September 6, 2001
5928-01-20238

**SUBJECT: ADDITIONAL INFORMATION - LICENSE CHANGE APPLICATION
NO. 291 – ONCE THROUGH STEAM GENERATOR (OTSG)
SURVEILLANCE SPECIFICATIONS APPLICABILITY FOLLOWING
CYCLE 13**

**THREE MILE ISLAND, UNIT 1 (TMI UNIT 1)
OPERATING LICENSE No. DPR-50
NRC DOCKET No. 50-289**

Changes to AmerGen Engineering Report, ECR No. TM 01-00328 (Hand Marked Pages)

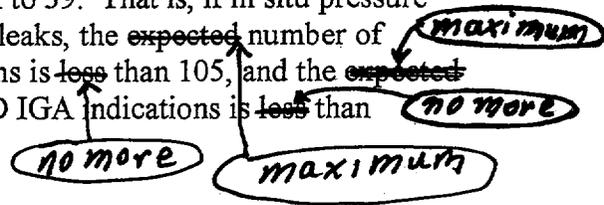
Page 33: In section 8.3.3, "Step 1c. Perform Paired t-Tests for Change in ID IGA Population," to correct errors indicating that the test is a two-sided test rather than a one-sided test; the mathematical expression " $\alpha/2$ " is being changed to " α " in two equations on that page.

Attachment 3 provides a hand markup of pages 33 and 39 of the engineering report showing these changes.

$$t_{1-\alpha/2}$$

$t_{1-\alpha/2}$ = percentile of the t distribution, taken from Table A-4 of Reference 2.14, as a function of level of significance, α and degrees of freedom, df

$$u_{crit} = t_{1-\alpha/2} \frac{s}{\sqrt{n}}$$
